Access Compliance Report

Public Rights-of-Way

Intersection ID: 10036258	Main Street: ROMANY_RD	Cross Street: N/A	Location: SW
ADA ID: EF1C449B368B	Ramp Type: PerpDiag	Initial Pass/Fail: Fail	Overall Compliance: No
		Severity Score: 35

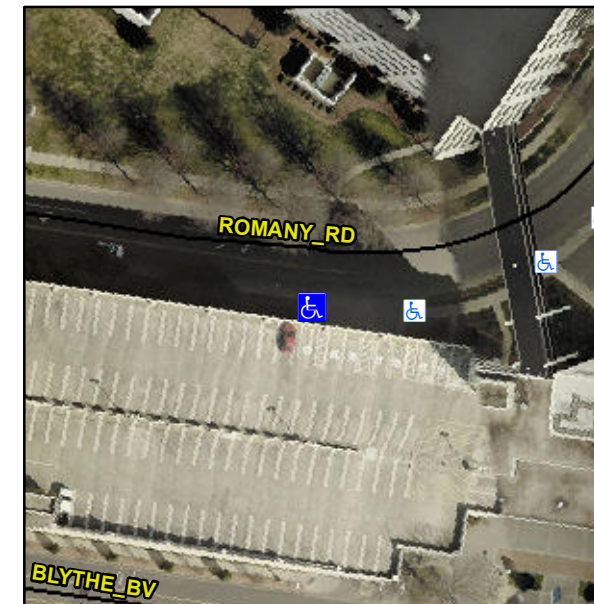
R304.5.1, R304.2.2, R304.5.3

Compliance	Description	Data	Compliance	Description	Data
N/A	Ramp Length (in)	44.0	No	Ramp Slope (%)	16.2
No	Ramp Width (in)	37.0	No	Ramp XSlope (%)	2.9
N/A	Flare Type LT	N/A	N/A	Flare Type RT	N/A
N/A	Flare Slope LT (%)	N/A	N/A	Flare Slope RT (%)	N/A
N/A	Flare Traversable LT?	N/A	N/A	Flare Traversable RT?	N/A
N/A	Landing Length (in)	N/A	N/A	DWS Provided?	N/A
N/A	Landing Width (in)	N/A	N/A	DWS Contrast?	N/A
N/A	Landing Slope (%)	N/A	N/A	DWS Length (in)	N/A
N/A	Landing X Slope (%)	N/A	N/A	DWS Full Width?	N/A
N/A	Landing Curb? (Y/N)	N/A	N/A	DWS Offset (in)	N/A
N/A	Shared Landing?	N/A			
N/A	Gutter Ponding?	N/A	N/A	Gutter Slope (%)	N/A
N/A	Gutter Lip Ht (in)	N/A	N/A	Gutter X Slope (%)	N/A
N/A	Painted X Walk1?	No	N/A	Painted X Walk2?	No
	X Walk 1 Direction	To NE		X Walk 2 Direction	To NW
N/A	X Walk 1 Width (in)	N/A	N/A	X Walk 2 Width (in)	N/A
	X Walk 1 Slope (%)	0.4		X Walk 2 Slope (%)	0.9
	X Walk 1 X Slope (%)	3.3		X Walk 2 X Slope (%)	2.0

Remove & Replace Curb Ramp With Two New Directional Ramps or Equivalent.
